Well Name: POKER LAKE UNIT 28 BS	Well Location: T25S / R31E / SEC 28 / SENE / 32.101858 / -103.776667	County or Parish/State: EDDY / NM
Well Number: 408H	Type of Well: OIL WELL	Allottee or Tribe Name:
Lease Number: NMLC062140	Unit or CA Name: POKER LAKE UNIT	Unit or CA Number: NMNM71016X
US Well Number:	Operator: XTO PERMIAN OPERATING LLC

Type of Submission: Notice of Intent

Type of Action: APD Change

XTO Permian Operating, LLC. respectfully requests approval to make the following changes to the approved APD. Changes to include KOP, FTP, LTP, BHL, and Proposed total Depth.
No additional surface disturbance.

ACREAGE DEDICATION PLATS

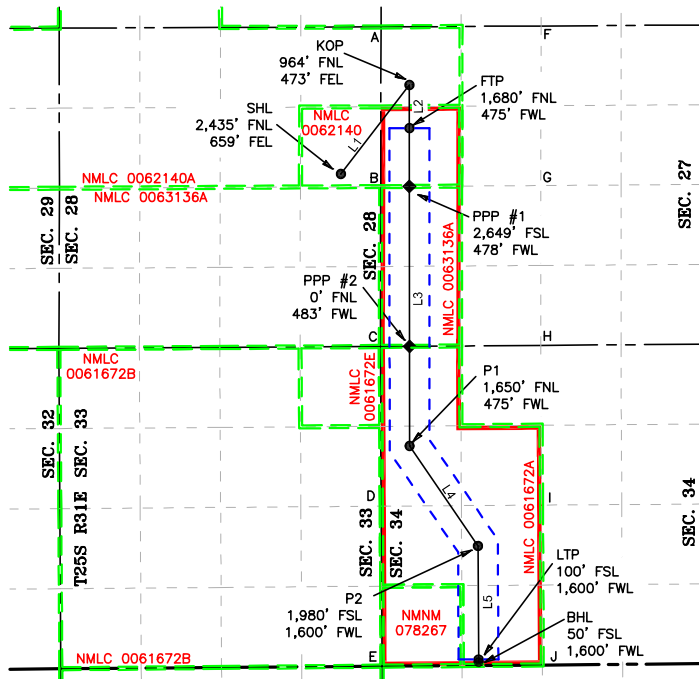
KOP: 2435 FNL & 659 FEL OF SECTION 28-T25S-R31E 964 FNL & 473 FEL OF SECTION 27-T25S-R31E
FTP: 2435' FNL & 330' FEL OF SECTION 28-T25S-R31E 1680' FNL & 475' FWL OF SECTION 27-T25S-R31E
LTP: 100' FSL & 330' FEL OF SECTION 4-T26S-R31E 100' FSL & 1600' FWL OF SECTION 34-T25S-R31E
BHL: 50' FSL & 330' FEL OF SECTION 4-T26S-R31E 50' FSL & 1600' FWL OF SECTION 34-T25S-R31E

The proposed total depth is changing from 24831 MD; 11039 TVD (Bone Spring 3 Shale) to 19246 MD; 9445 TVD (Bone Spring 1 Sand).
